Zingerman's Deli Expansion

05/18/10 Planning Staff Report

PLANNING AND DEVELOPMENT SERVICES STAFF REPORT

**SUBJECT: Zingerman's Deli Expansion Site Plan for City Council Approval
(418 – 422 Detroit Street and 322 East Kingsley Street)
File No. SP10-009**

LAYOUT PLAN

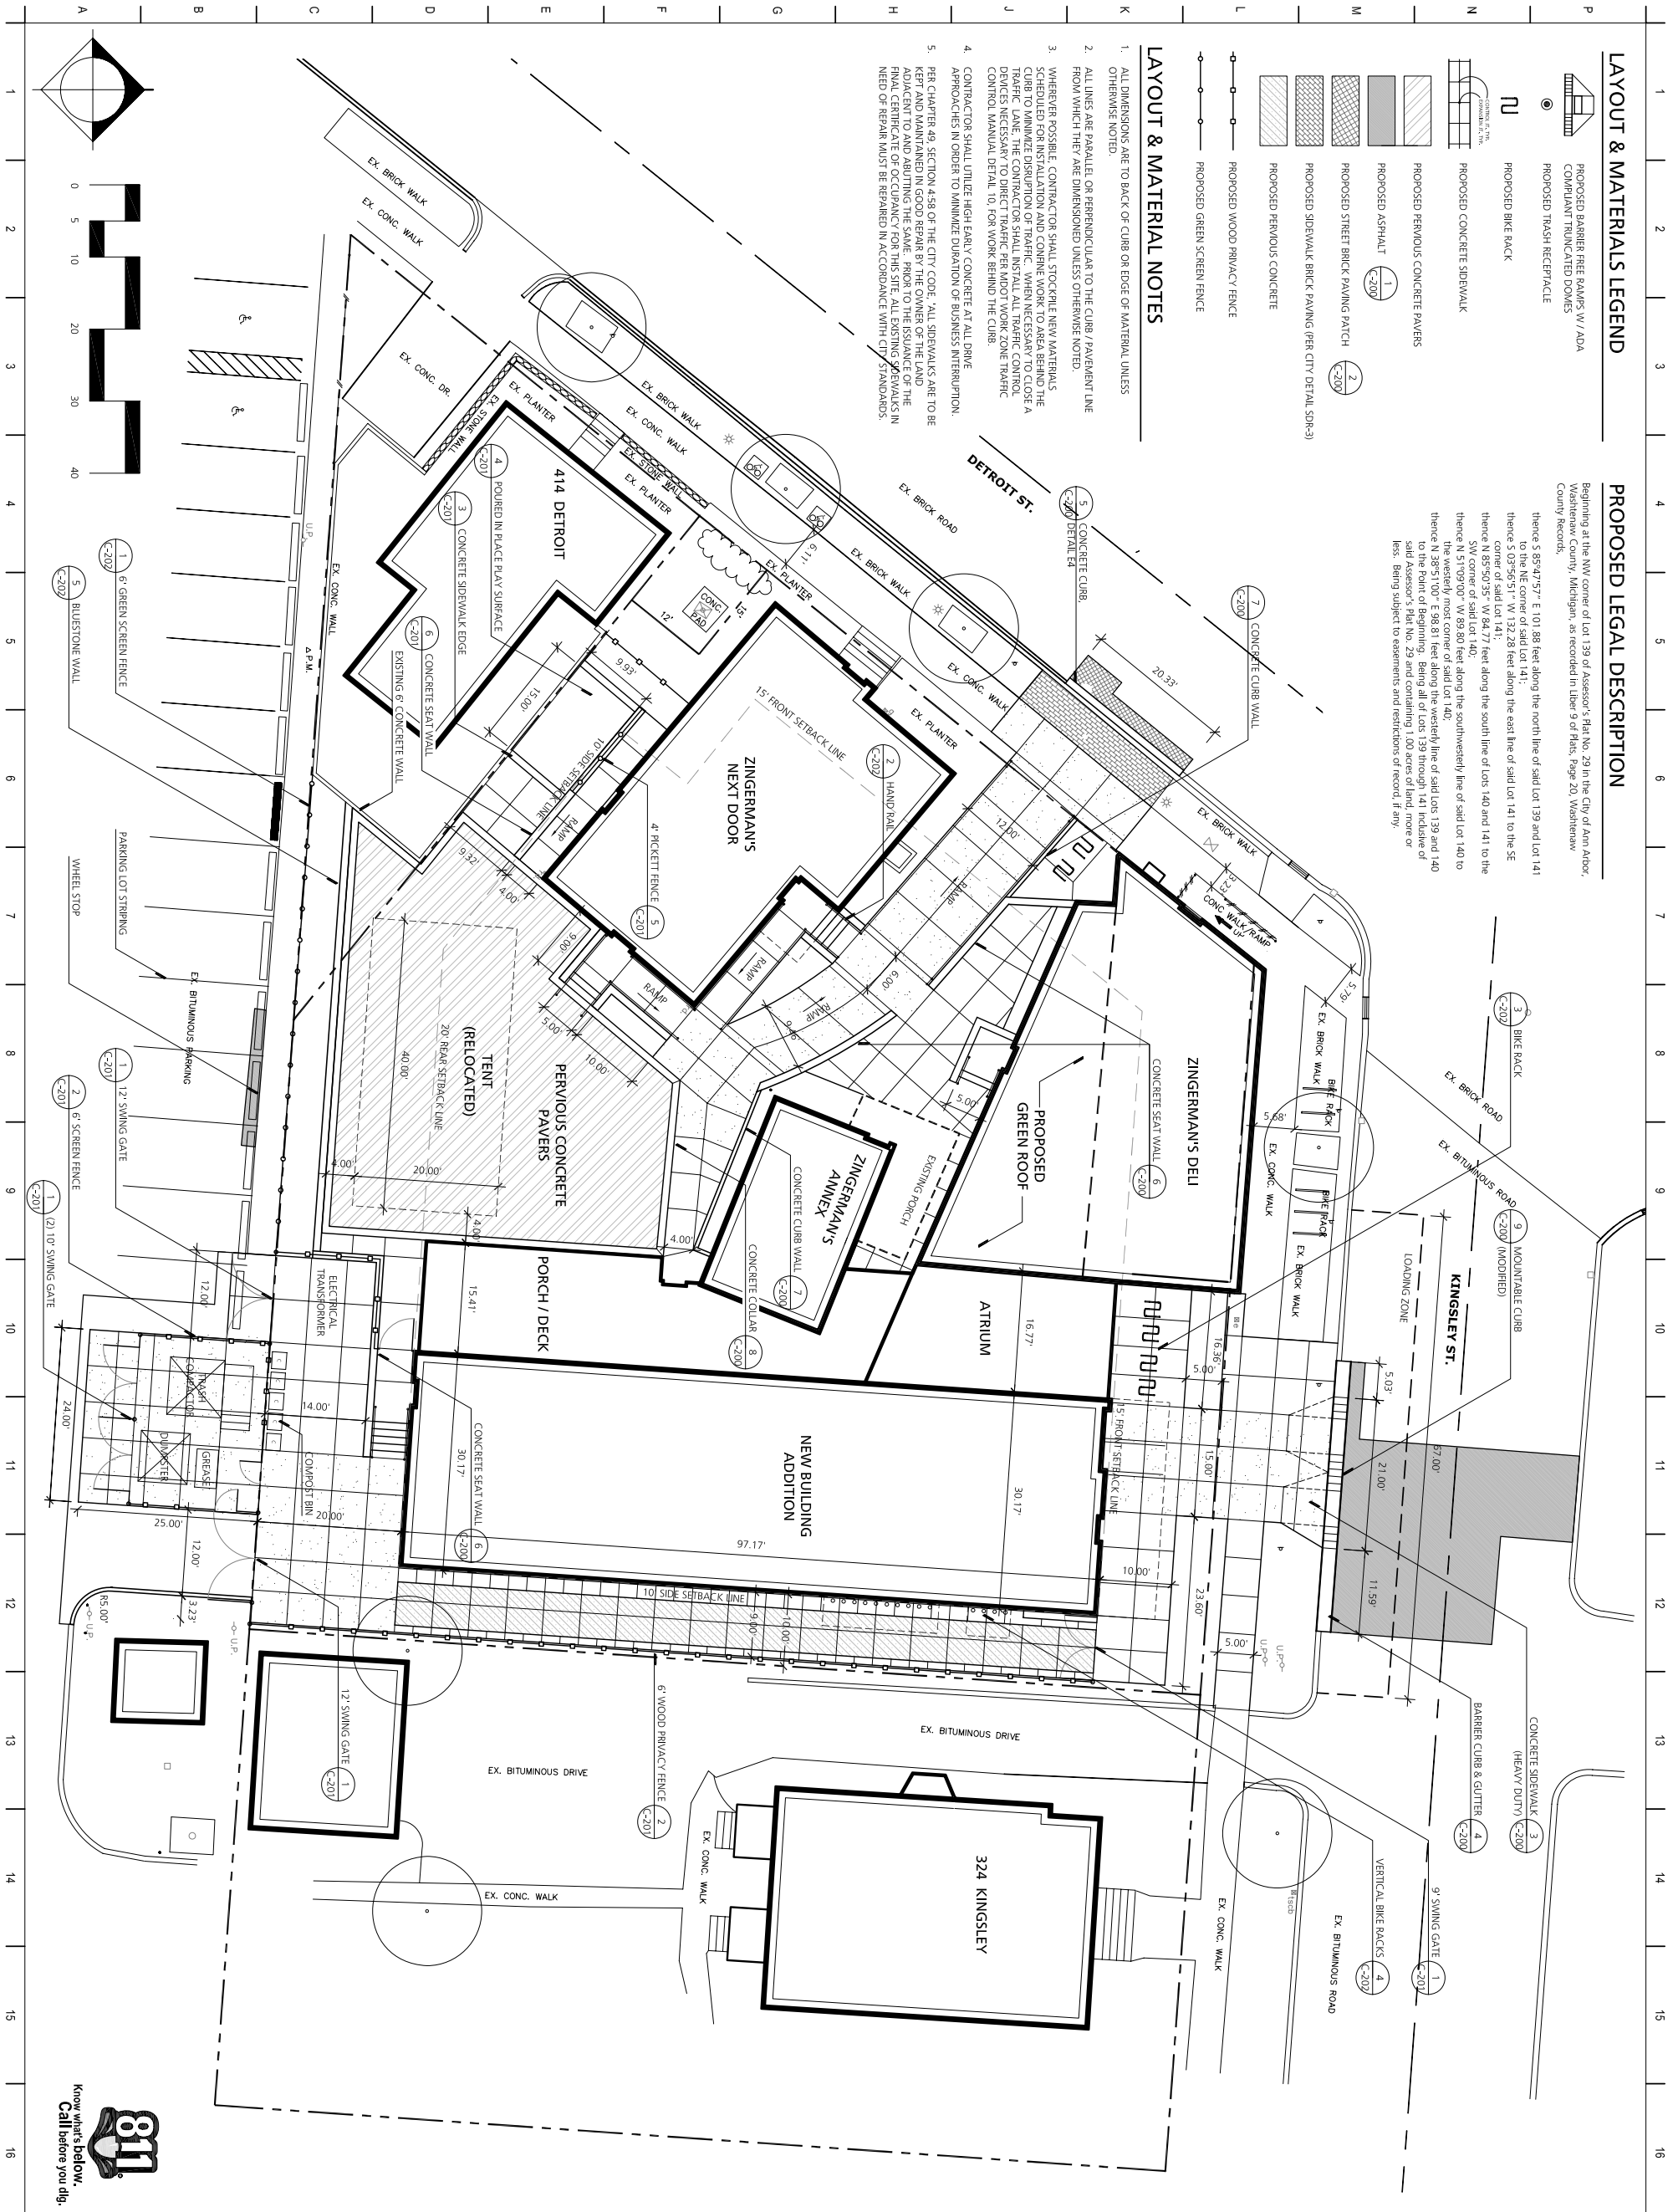
Systems Planning -- A Type M drive approach is shown on East Kingsley Street, while the response letter indicates that the driveway has been eliminated. Per Chapter 47, Section 4:20, useless curb cuts are not permitted. Barrier curb shall be placed in all areas where there are no curb cuts.

**LANDSCAPE
PLAN**

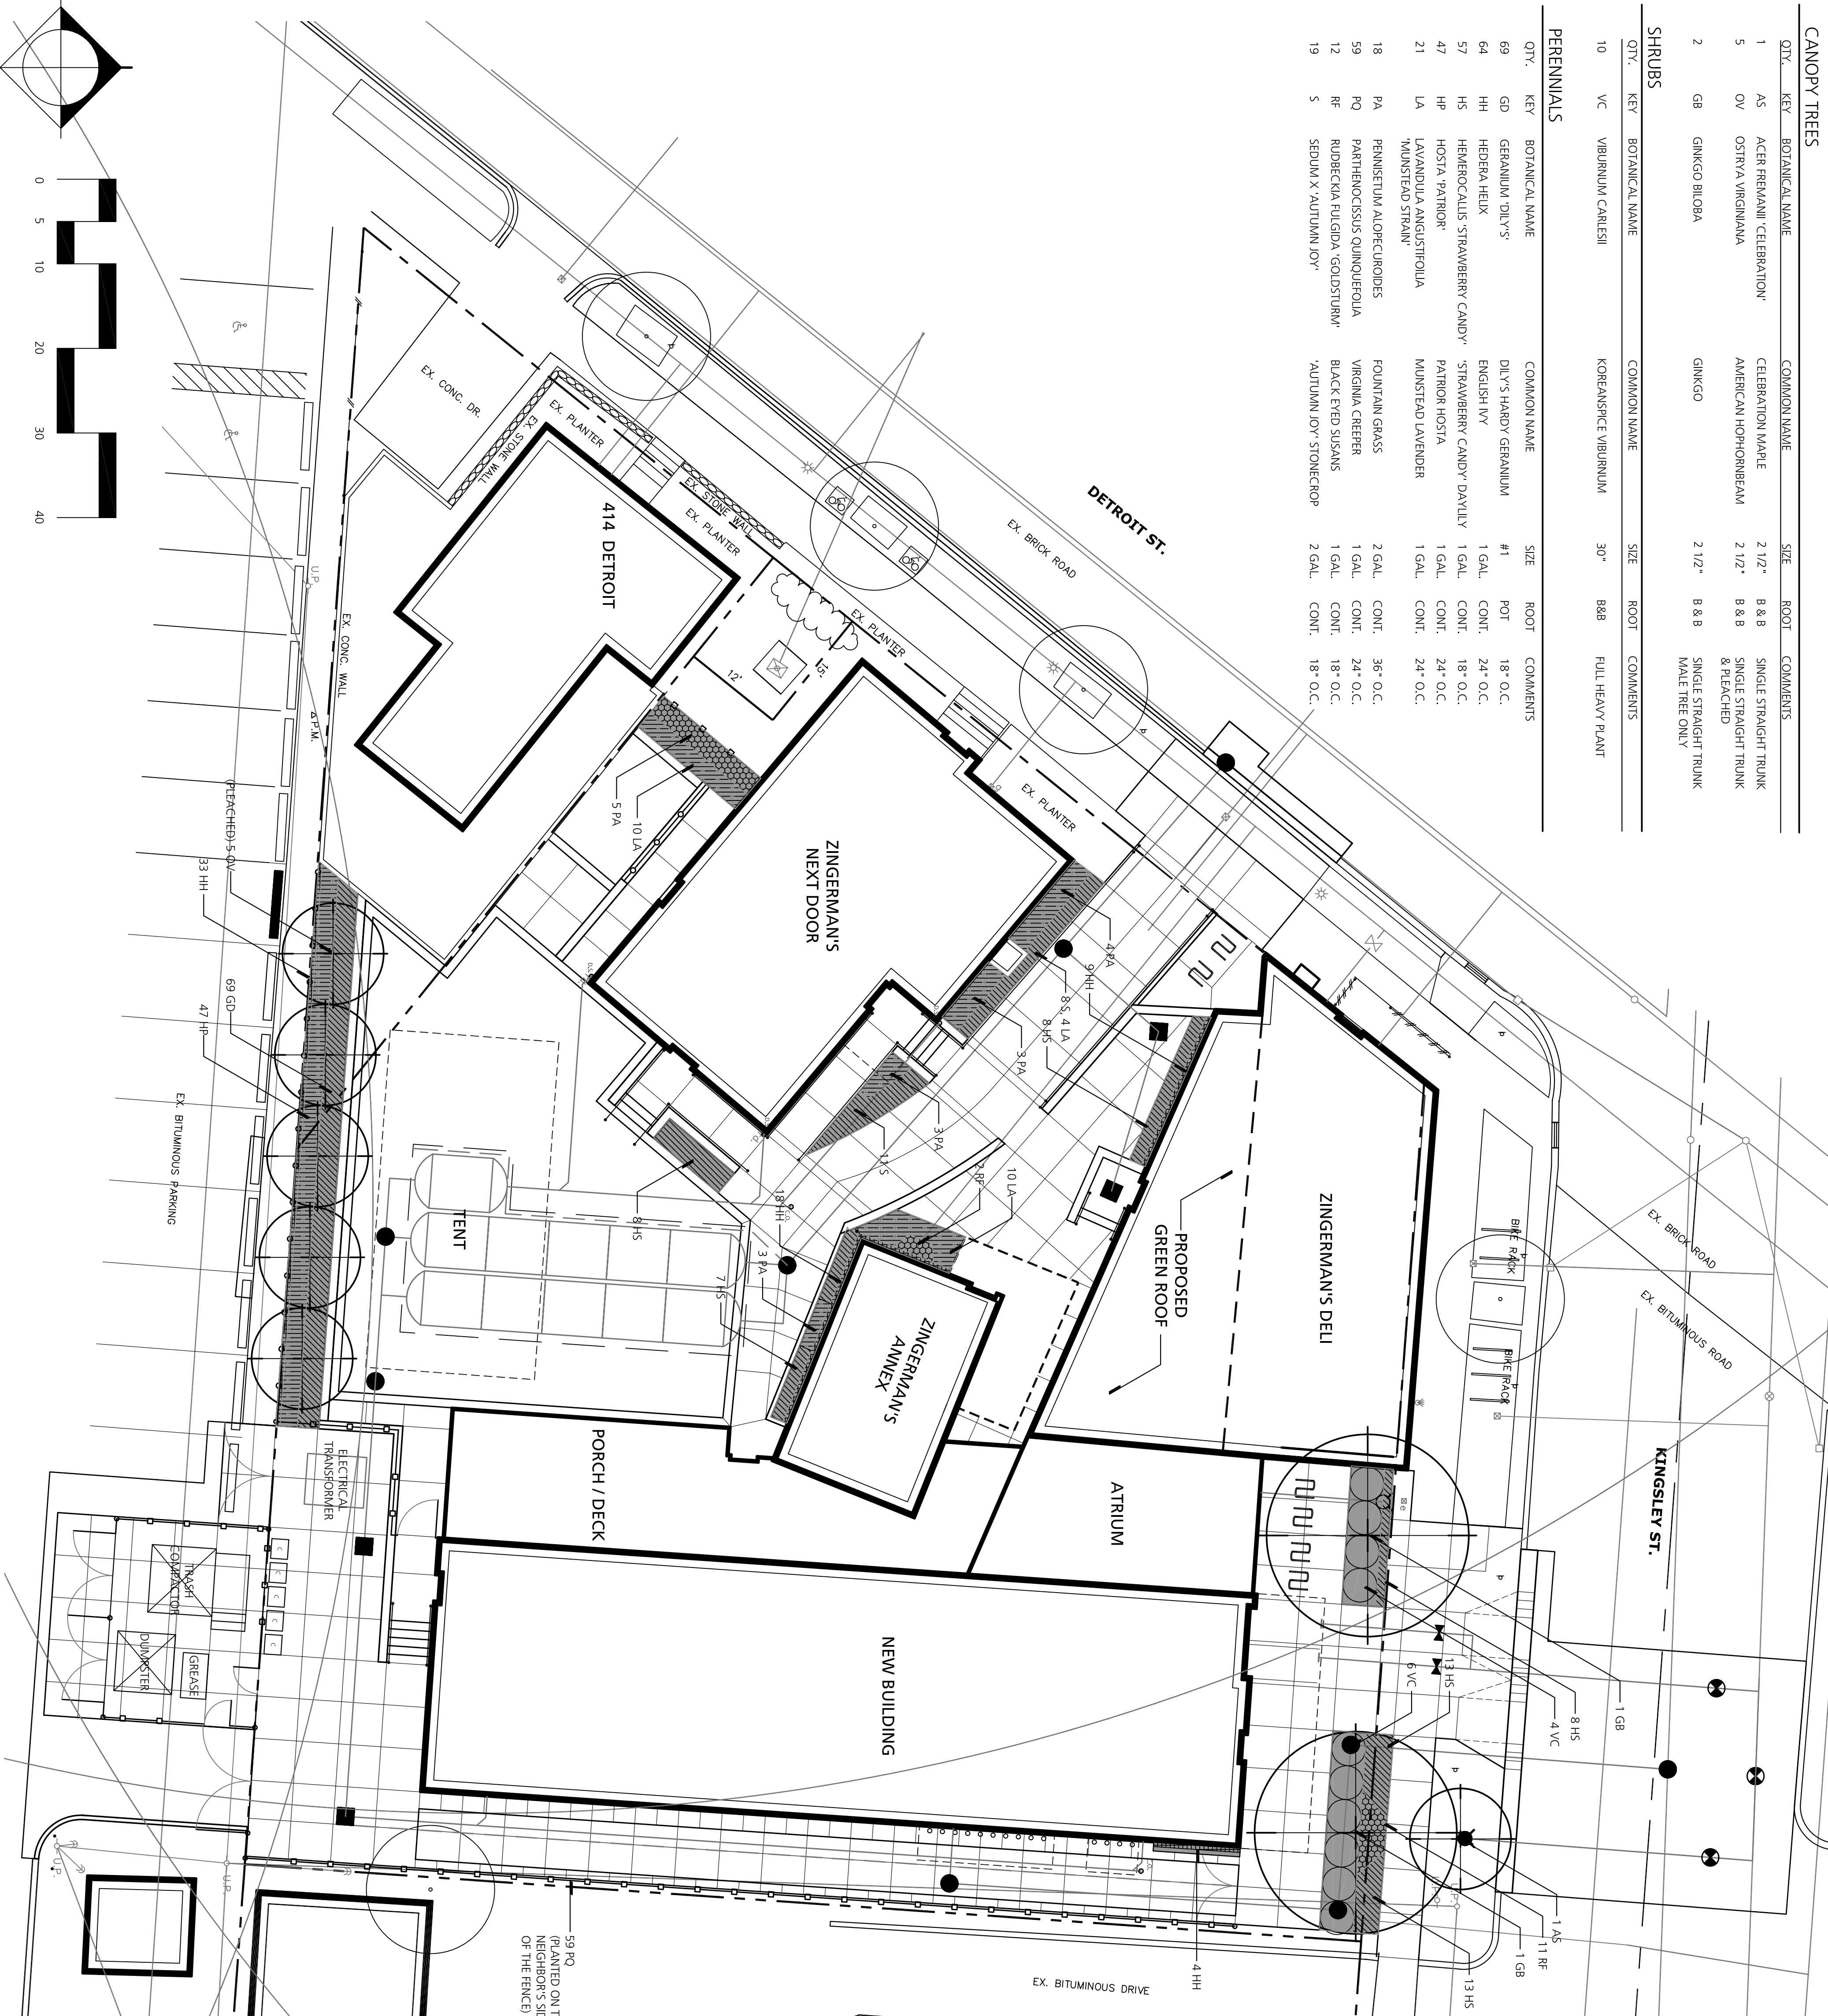
The petitioner has requested a modification of the conflicting land use buffer width and landscaping requirements along the east property line to allow a six-foot tall privacy fence to satisfy the buffer requirement.

The Zingerman's Deli property is located in the City's D2 Zoning District, automatically designated as a special parking district by Chapter 59 (site condition (i)). The D2 Zoning District allows a minimum ten-foot side yard setback, which has been provided on the site plan. This is consistent with the intent of D2 to promote a more dense, urban and mixed-use environment. As such, the placement of a 15-foot landscaped buffer would result in a more suburban treatment of the side yard interface with the neighboring property and conflict with the intention of the D2 zoning and A2D2 Plan for downtown Ann Arbor.

Both Planning and Land Development staff feel that this proposal meets the spirit and intent of Chapter 62.
